RFQ NUMBER
CHA0802

| LINE | QUANTITY | UOP | CAT NO | ITEM NUMBER | UNIT PRICE | AMOUNT |
|--------------------------------------------------------------------------------------------------------------------|----------|-----|--------|-------------|------------|--------|
| ----- ADDENDUM NO. 1 ----- | | | | | | |

Coal Heritage RFQ CHA0802

Coal Heritage Area - Interpretive Wayside Project

Ref. Item #6

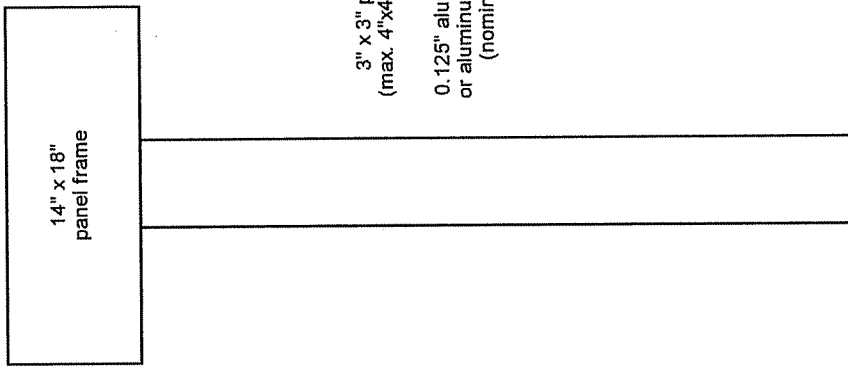
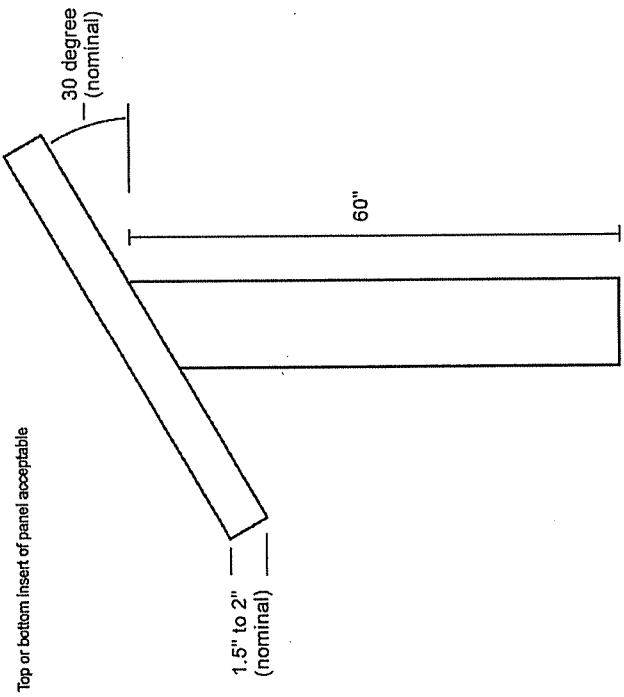
6) Item # 6 - There is no drawing attached for the exhibit unit. Is there a drawing available, if so could you please provide the drawing to the Vendor.

Response - Yes, please see Item #6 attached.
